MANDATORY SERVICE BULLETIN

NUMBER: SB-032
REVISION: A
DATE: 10/26/2010

SUBJECT: NOSE WHEEL STEERING, Mandatory Steering Bungee Inspection and Modification

KODIAK 100 Series Aircraft Serial Numbers:
• **100-0001 through 100-0044**

Figure 1: Steering Bungee Inspection Location

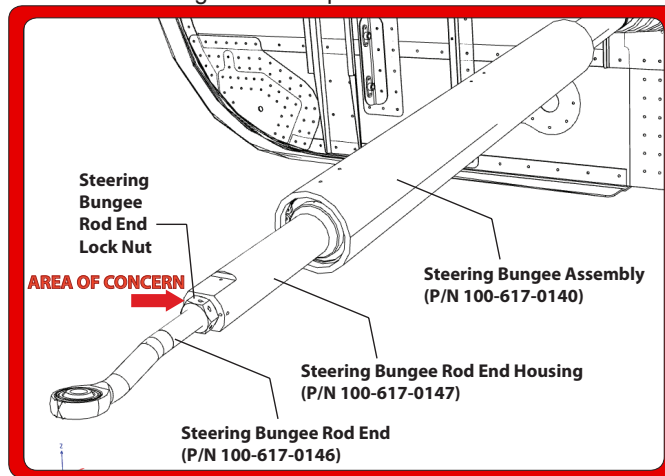
Quest Aircraft Company has received a single report that during a maintenance inspection of a KODIAK 100, excessive movement and play was found between the Steering Bungee Rod End Housing (P/N 100-617-0147) and the Steering Bungee Rod End (P/N 100-617-0146) with the Lock nut tightened to specifications.

Quest Aircraft Company is mandating a one-time inspection and modification to check the Steering Bungee (P/N 100-617-0140) for movement in the area where the Steering Bungee Rod End Housing (P/N 100-617-0147) connects to the Steering Bungee Rod End (P/N 100-617-0146) (See Figure 1). The Steering Bungee modification (FSI-018) consists of installation of a Locking End Cap to the Steering Bungee.

2. Inspect the Steering Bungee assembly (*P/N 100-617-0140*) for movement in the area where the Steering Bungee Rod End Housing (*P/N 100-617-0147*) connects to the Steering Bungee Rod End (*P/N 100-617-0146*) (See **Figure 1**):

- a. Manually move the Steering Bungee in all directions at the area of concern noted in **Figure 1**. Observe for movement between the Steering Bungee Rod End Housing (*P/N 100-617-0147*) and the Steering Bungee Rod End (*P/N 100-617-0146*). There should be no relative movement between the two. If movement is found, the Steering Bungee Rod End Lock Nut should be verified for proper torque (reference the KODIAK 100 Maintenance Manual, 180-200 in-lbs). If relative movement is still found, contact Quest Aircraft for a replacement Steering Bungee assembly.

1. Once **Section 1** is complete, perform the instructions in **FSI-018** to modify the Steering Bungee within the time frame listed in the Compliance Section on **Page 1**. This modification installs a Locking End Cap to the Steering Bungee Rod End (*P/N 100-617-0146*) assembly.
